Re: Matter of the Application of Hydro Resources Inc., Docket No. 40-8968-ML,
ASLBP No. 95-706-01-ML

**INTERVENORS' RESPONSE TO HYDRO RESOURCES INC.'S COST ESTIMATES
AND RESTORATION ACTION PLAN OF NOVEMBER 21, 2000**

**WRITTEN TESTIMONY OF MR. STEVEN C. INGLE IN SUPPORT OF
INTERVENORS' RESPONSE TO HYDRO RESOURCES INC.'S COST ESTIMATES
AND RESTORATION ACTION PLAN OF NOVEMBER 21, 2000**

FIGURE 1
'IDEAL' 5-SPOT PATTERN

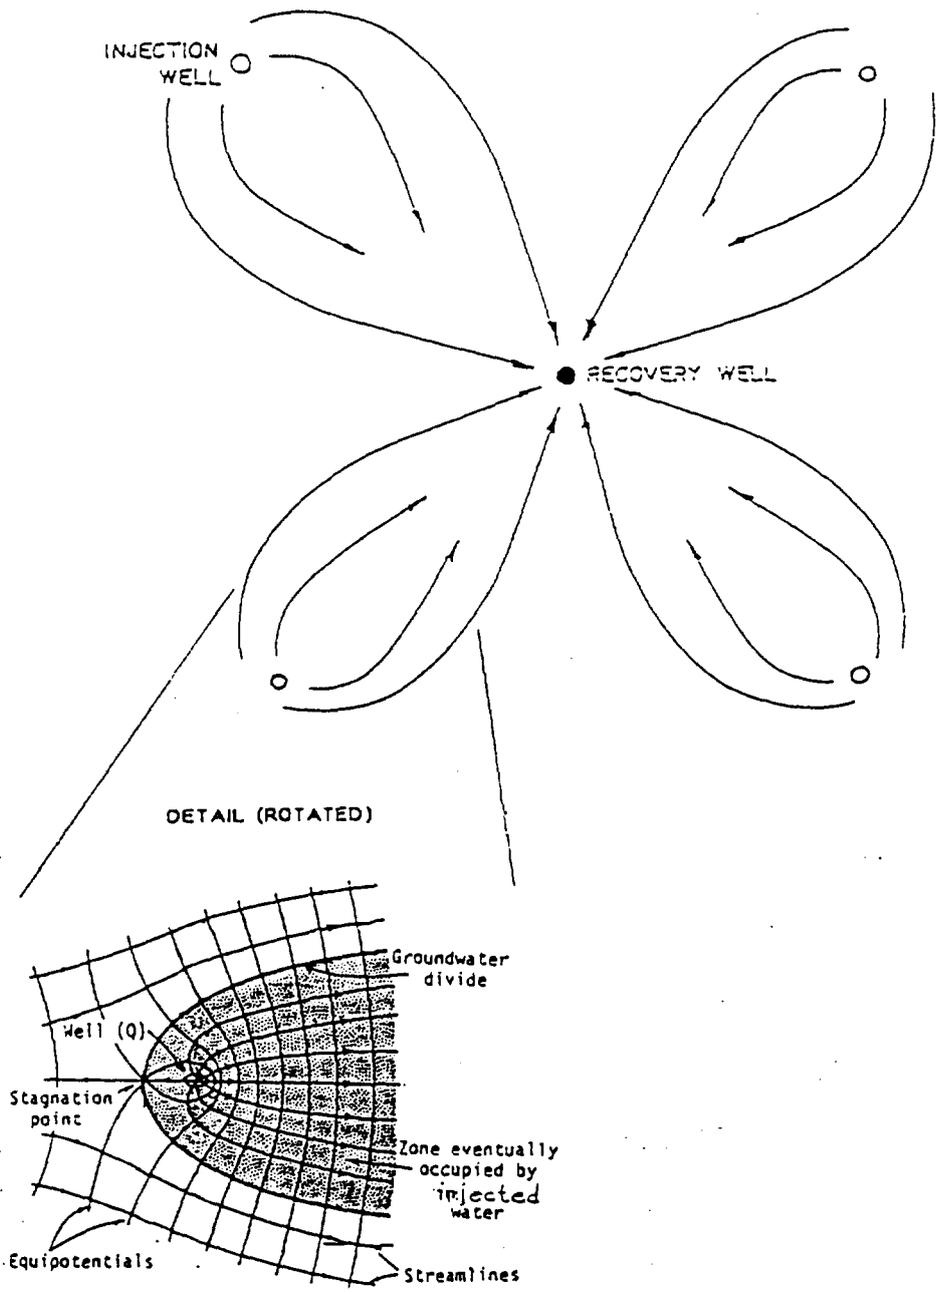
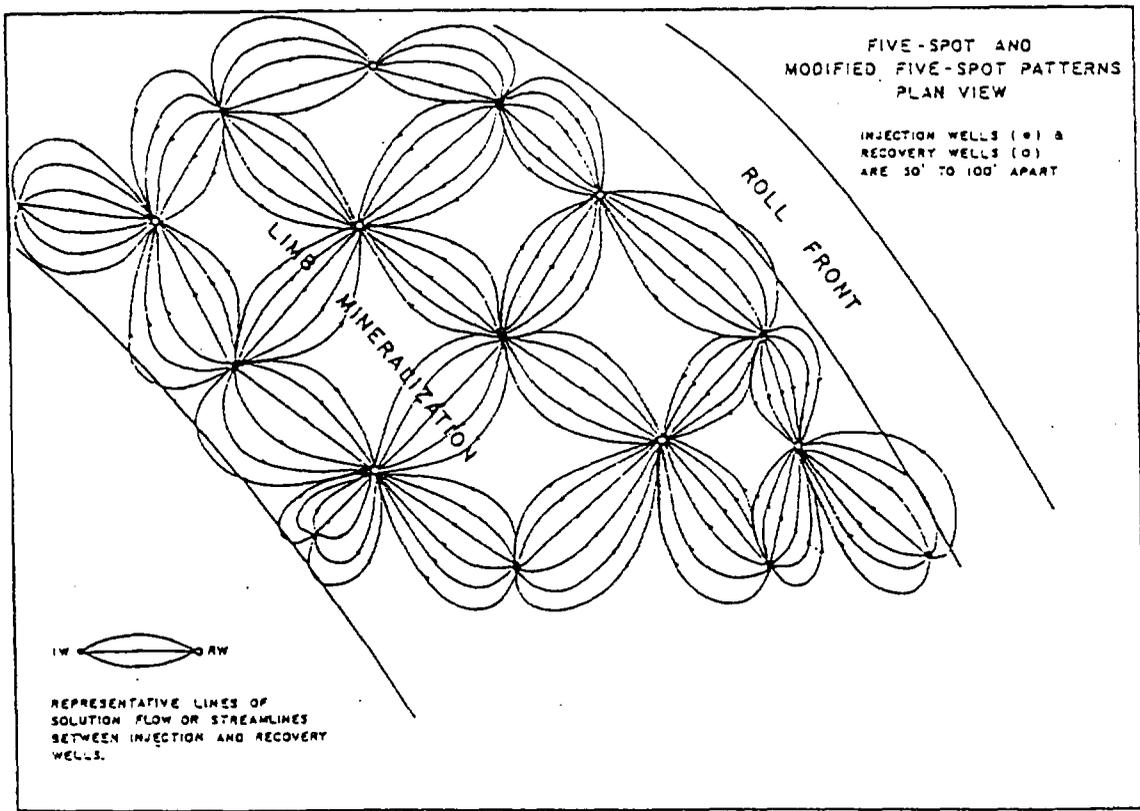
and WDEQ's estimated pore volumes is appended to my testimony as **Attachment C**. The MODFLOW simulation was performed using an existing "ideal" wellfield pattern used by PRI at the Highland Project. **Ex. B, Figure 1**. The pattern was optimally balanced and the simulation run to steady state conditions. The portion of MODFLOW that calculates groundwater flow velocity was then run and the extent of horizontal flare calculated.⁷

Figure 2.7. Schematic flow diagram and approximate flow rates of restoration wastewater treatment systems.

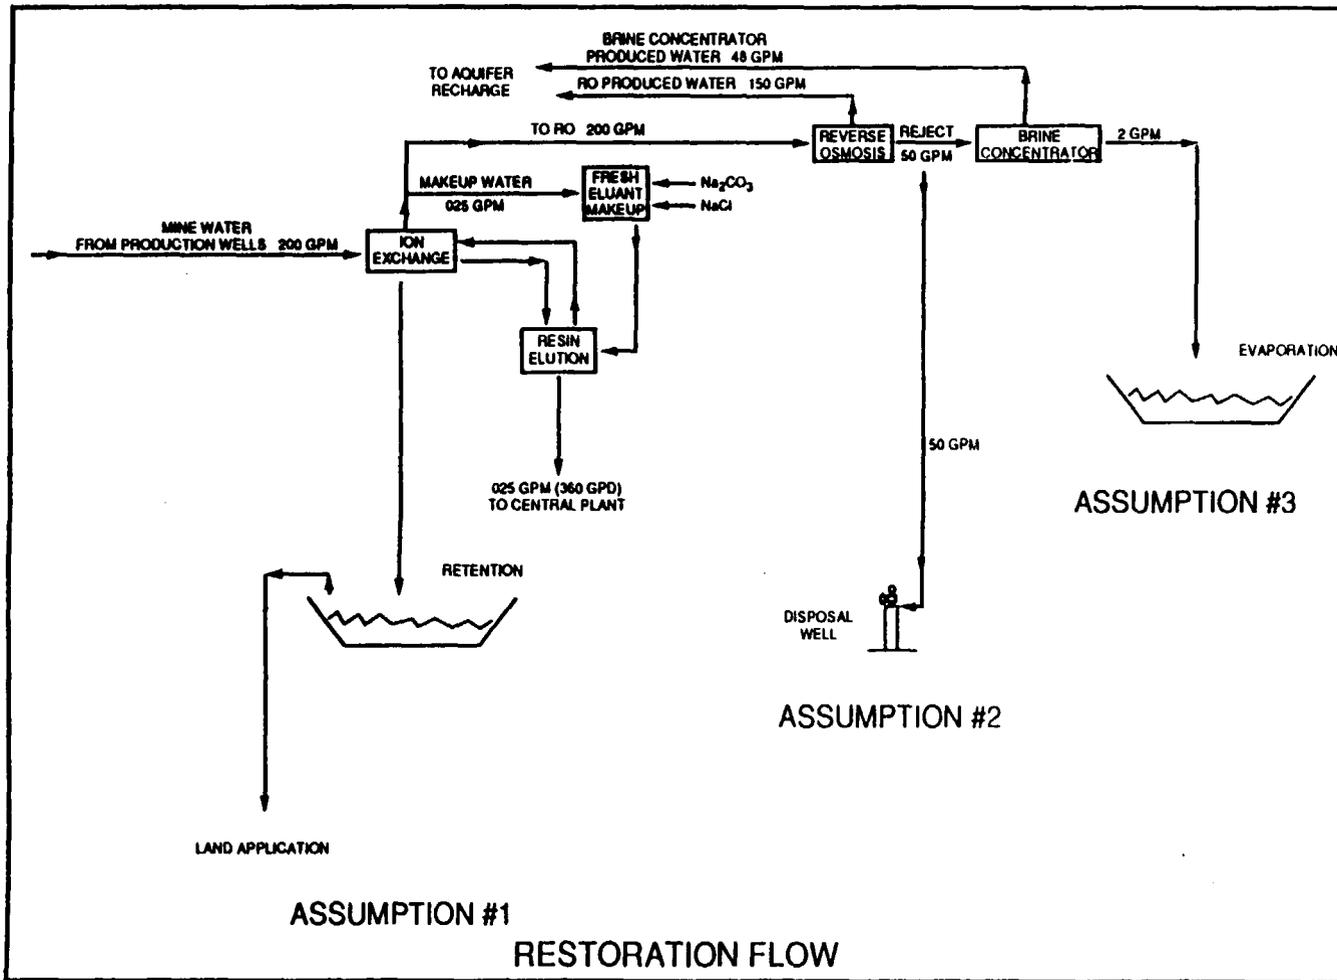
described in HRI's August 1997 Consolidated Operations Plan (Figure 10.4-1 at COP-162) and in the NRC's FEIS (Figure 2.7 at 2-22). In the COP and the FEIS, restoration flow diagrams were provided to show where the mining solutions were routed and how many gallons per minute of waste water were treated at each step of the process. I have copied these diagrams and included them in **Attachment E** attached hereto. In these diagrams, the RO unit generates 50 gpm of "reject" water (or 25% of the total flow) that enters the BC. In the RAP (which does not contain a similar flow diagram), 116 gpm of RO reject water (or 20% of the total flow) enters the brine concentrator. HRI does not discuss why the amount of restoration water entering the system has nearly tripled in the 3-plus years that have elapsed since the FEIS and the COP were prepared.
